Agilent Series V2800 Vector Signal Analyzer

Firmware Release Notes

V2820-90003

First edition, March 2010

Reference Level and Expected Power Fields with User Flatness Enabled

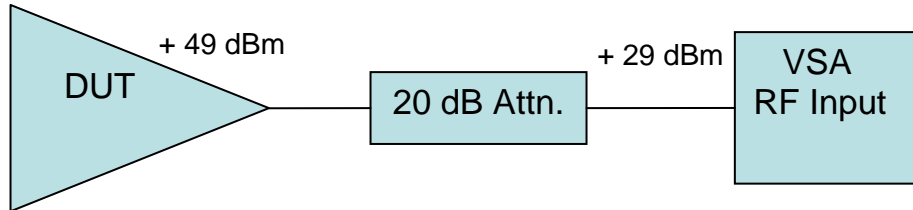
Starting with version 4.2 the Reference Level and Expected Power values in the Series V2800 measurements will be offset by the values in the User Flatness table when user flatness is enabled. This feature will allow the correct setup and display of signals with offset values in the user flatness table.

The following diagram is an example showing the impact of this change:

For the above test condition, a value of 20 dB should be entered in the user flatness table. The user flatness table allows up to 10 different values to be used across a range of frequencies. The frequency response of the attenuator and cables can be entered at 1 or more frequencies. When the user flatness correction is turned on, the reference level or expected power field on the Series V2800 measurement should be set to the actual output level of the device under test (DUT), + 49 dBm in this example. The measurement display will have a top value of + 49 dBm, allowing the complete signal to be visible. The Series V2800 input attenuation will be set for the actual value at the analyzer input, + 29 dBm in this example, to allow for maximum dynamic range in the measurement. The data values and trace will reflect the values at the DUT output by adding the value of the user flatness to the actual measured values.

Care should be taken to insure that power levels above the maximum rated input power are not input to the analyzer when testing high power amplifiers (as in the example above).
